**SOLICITATION AMENDMENT
MODIFICATION DE L'INVITATION**

Title - Sujet Bay 3 Refit	
Solicitation No. - N° de l'invitation 9F023-200546/A	Amendment No. - N° modif. 007
Client Reference No. - N° de référence du client 20200546	Date 2022-01-06
GETS Reference No. - N° de référence de SEAG PW-\$\$\$FG-380-80685	
File No. - N° de dossier fg380.9F023-200546	CCC No./N° CCC - FMS No./N° VME
Solicitation Closes - L'invitation prend fin at - à 02:00 PM Eastern Standard Time EST on - le 2022-01-21 Heure Normale du l'Est HNE	
F.O.B. - F.A.B. Plant-Usine: <input type="checkbox"/> Destination: <input type="checkbox"/> Other-Autre: <input type="checkbox"/>	
Address Enquiries to: - Adresser toutes questions à: Turner, Jason	Buyer Id - Id de l'acheteur fg380
Telephone No. - N° de téléphone (343) 574-2818 ()	FAX No. - N° de FAX () -
Destination - of Goods, Services, and Construction: Destination - des biens, services et construction:

Amendment 007 is issued for the following:

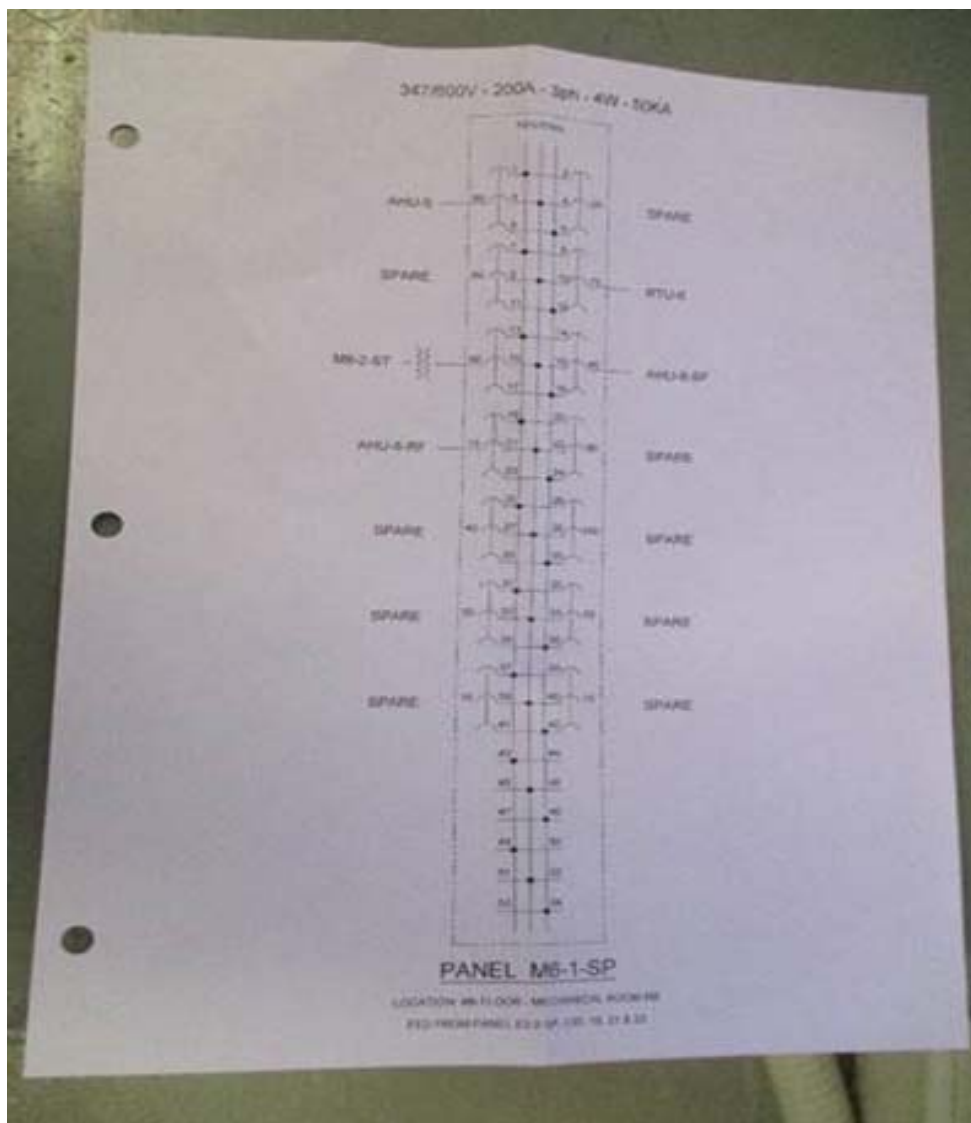
Question 5: For panel M6-1-SP we need to know the make and model of the panel and the KA rating of the two 150 amp breakers.

Answer 5: Please see photos below.
